Oakdale Central – Horsley Park

Construction of Warehouse and Distribution Facilities - Lots 1C, 2B and 3

Goodman Property Services (Aust) Pty
Limited
4 December 2012
Document No. 60197952

Oakdale Central VMP - Addendum

Drawing No. SKC118

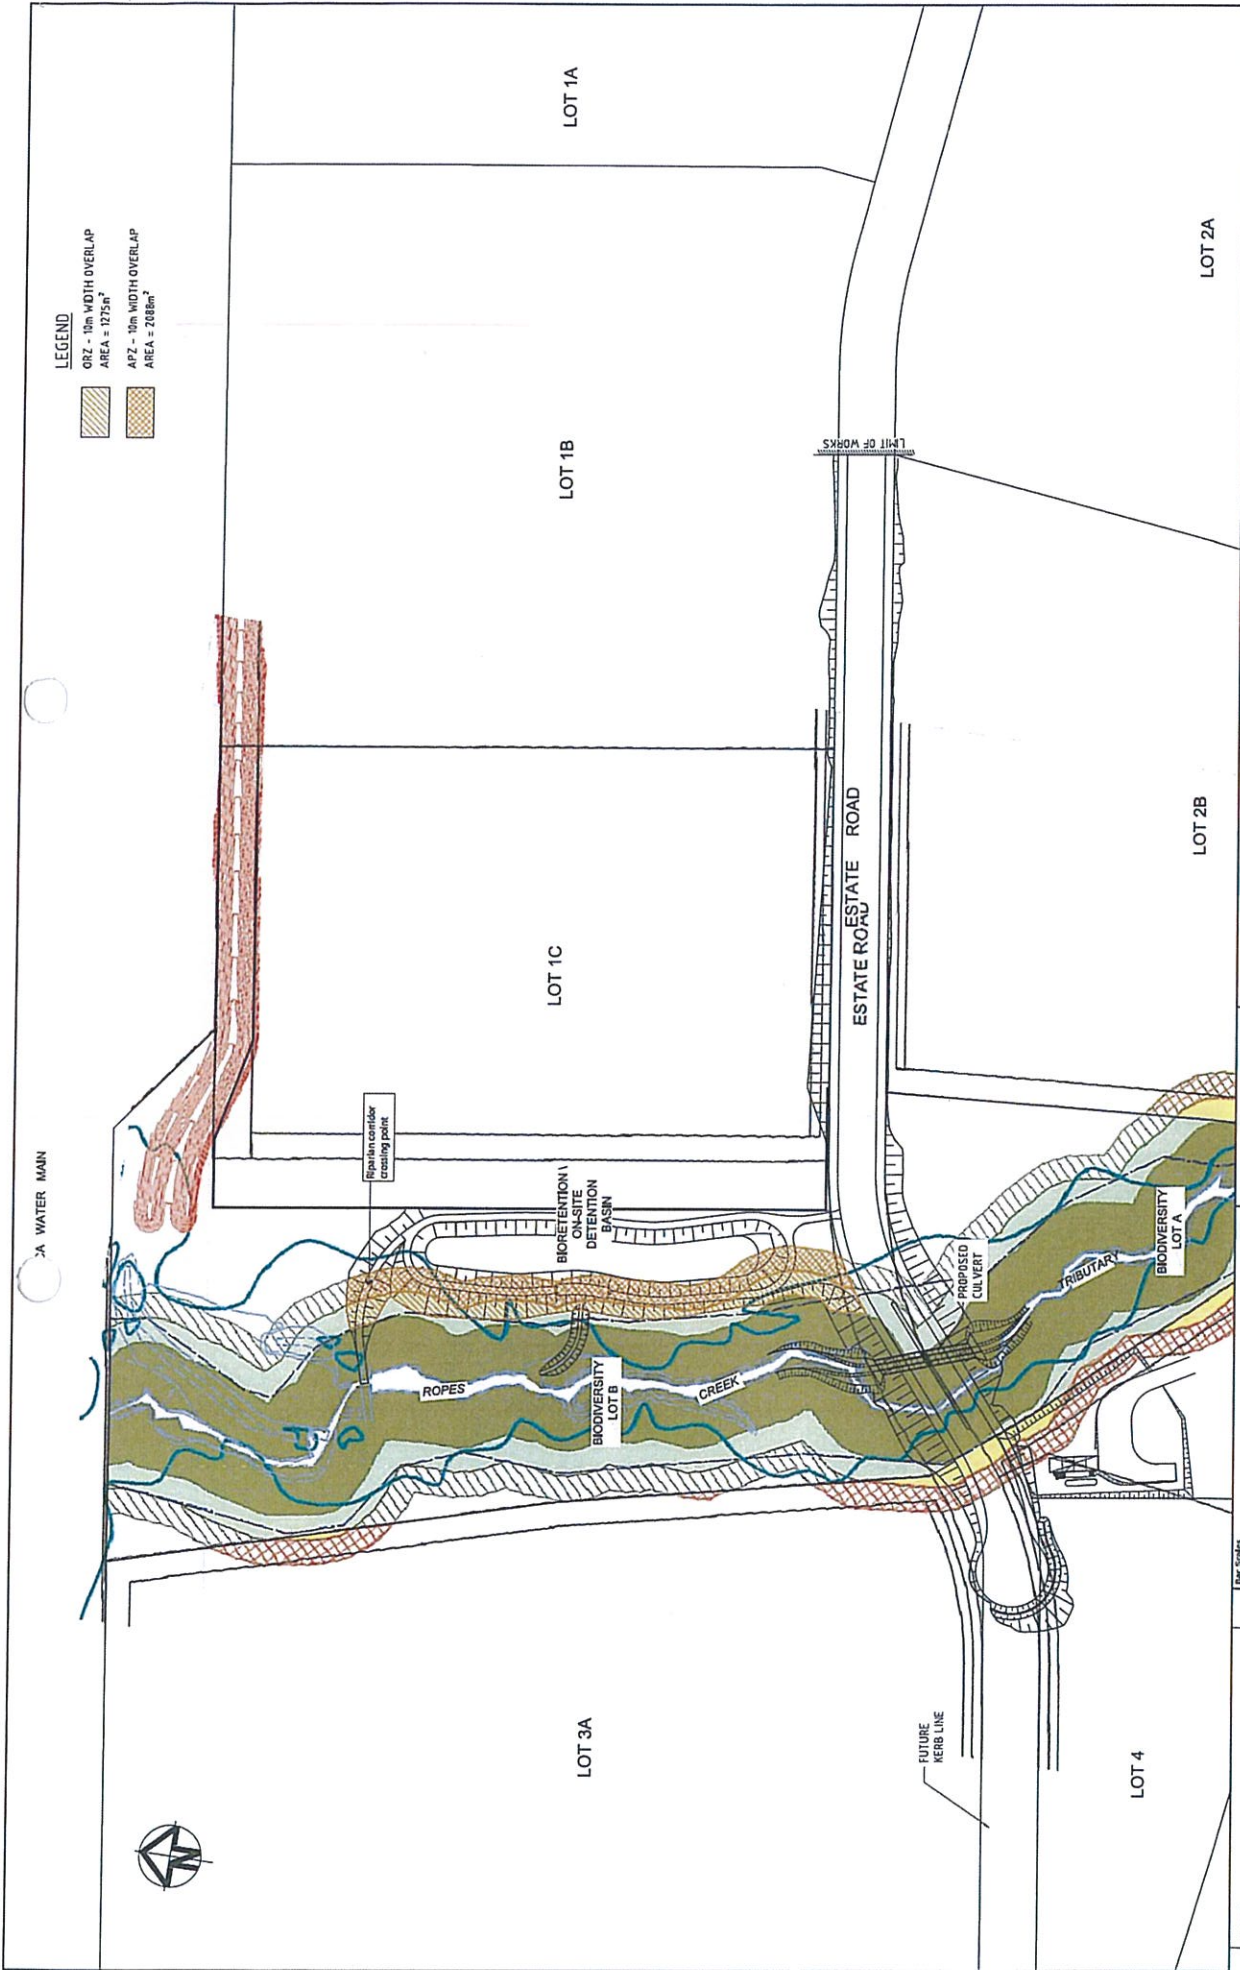
Attachment B shows the proposed modification. As can be seen from this attachment, the western wall of the basin and associated riparian corridor crossing point now encroaches into the ORZ of the riparian corridor. The area of encroachment is 1,275 sq.m¹.

Drawing No. SKC118 - Detail

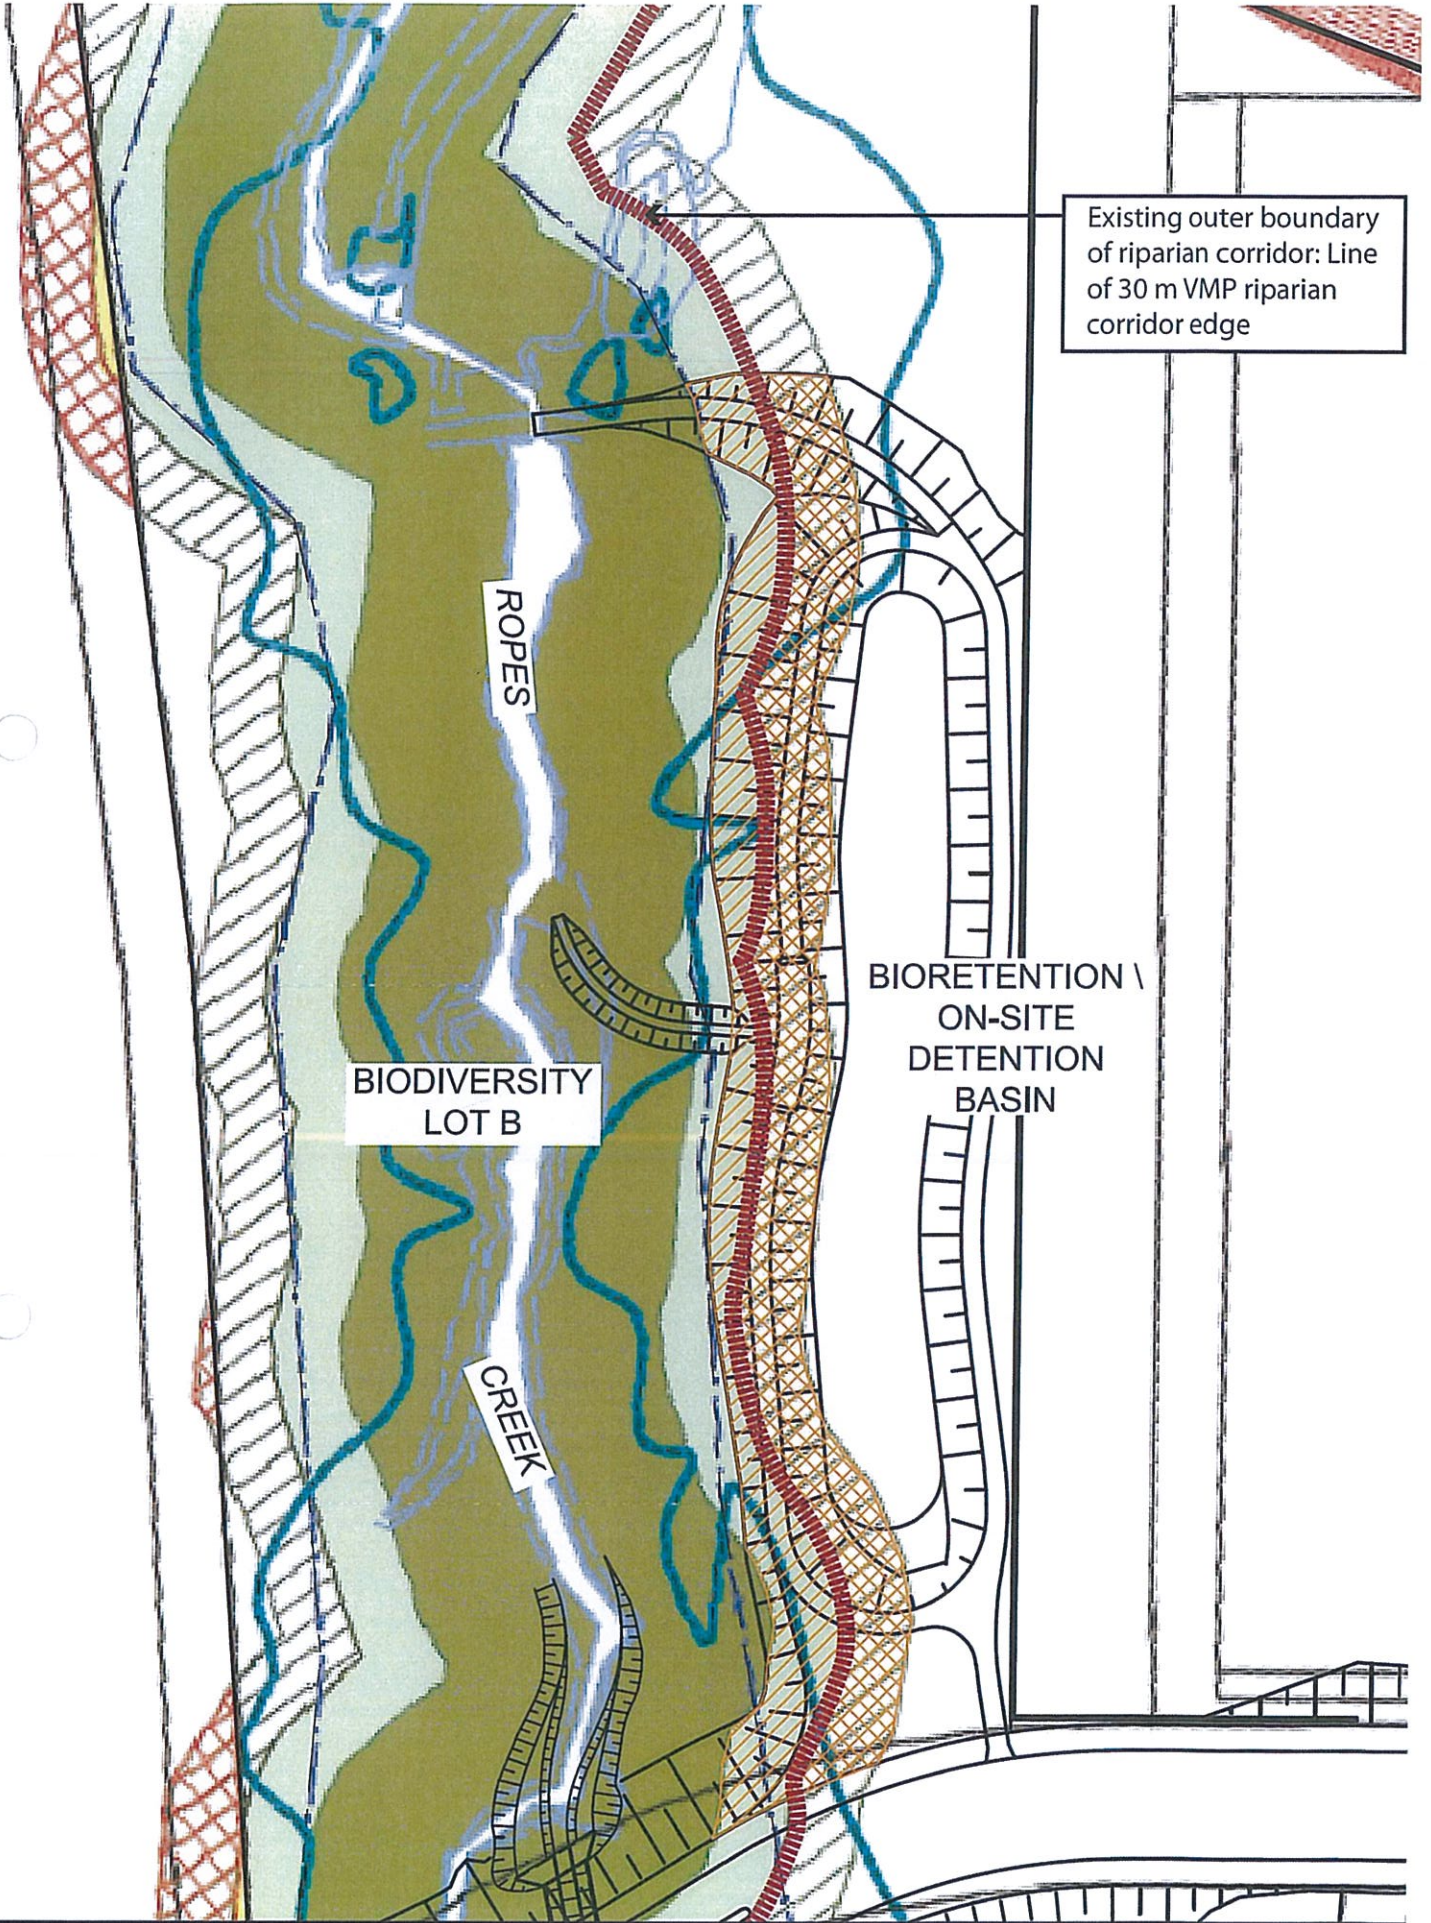
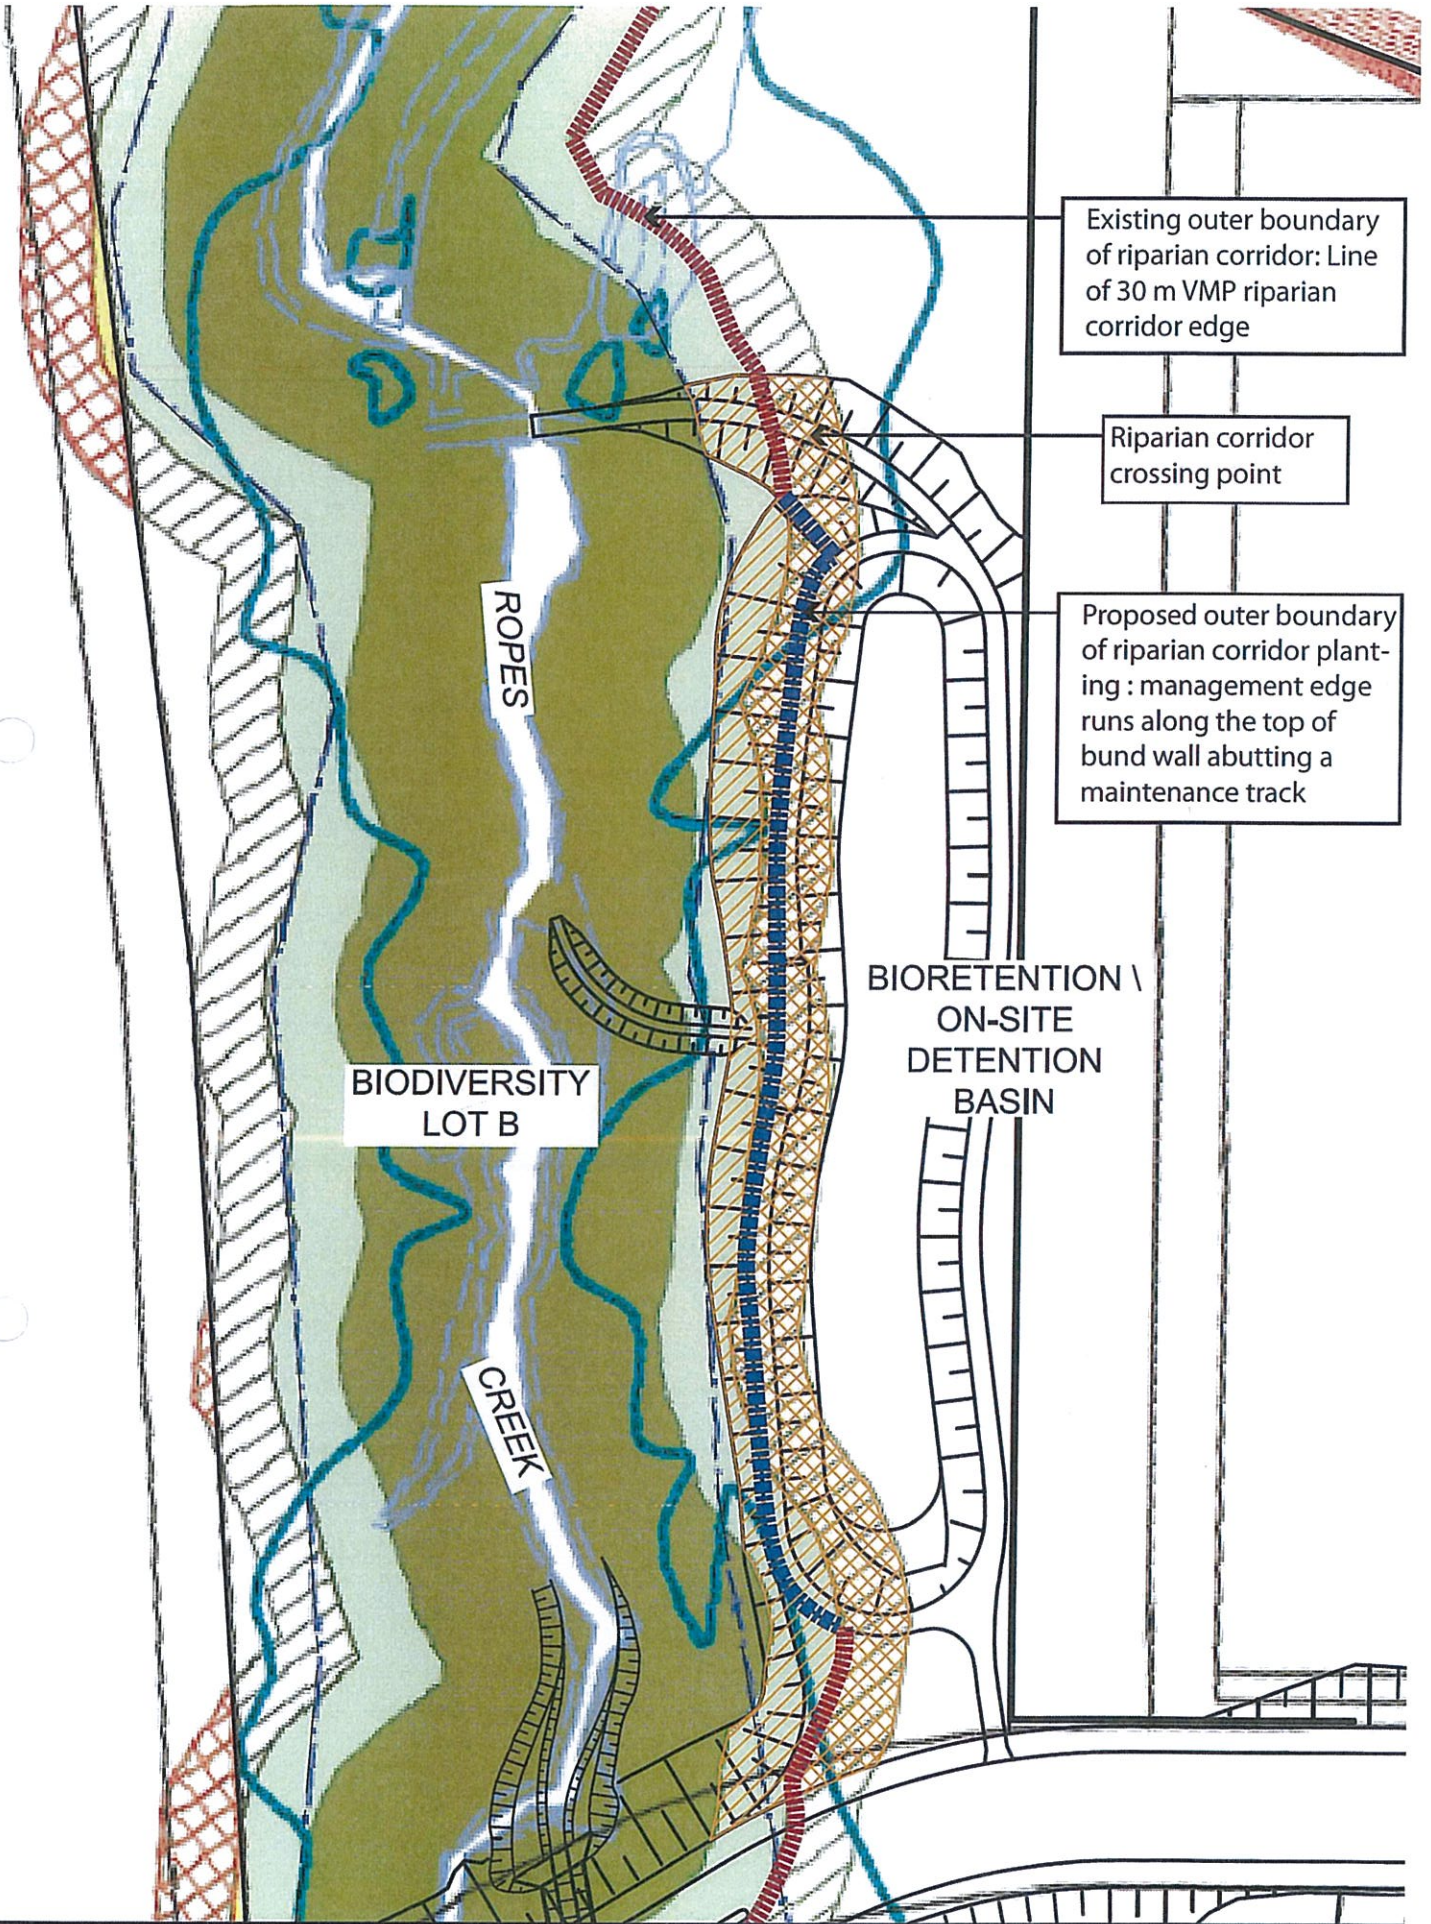
Attachment C shows an annotated detail of Attachment B, focussed on the area of the proposed basin. As can be seen, the existing outer boundary of the ORZ creates a waving line across the face of the basin wall. The riparian corridor planting along this line would abut an exotic grass treatment. This planting / grass edge is not a preferred long-term management boundary for the riparian corridor, as it provides a long edge that is susceptible to weed invasion. Goodman has therefore proposed to locally increase the amount of riparian planting on the basin batter, such that it abuts the maintenance track that runs around the top of the basin. This will create a substantially more weed resistant long-term management edge, and compensate for a small area at the southern end of the basin where the outer ORZ line runs over the basin wall and onto the inner basin batter.

The area of riparian planting to be provided to the basin wall and associated infrastructure as shown in Attachment D, will be treated in accordance with all provisions of the VMP.
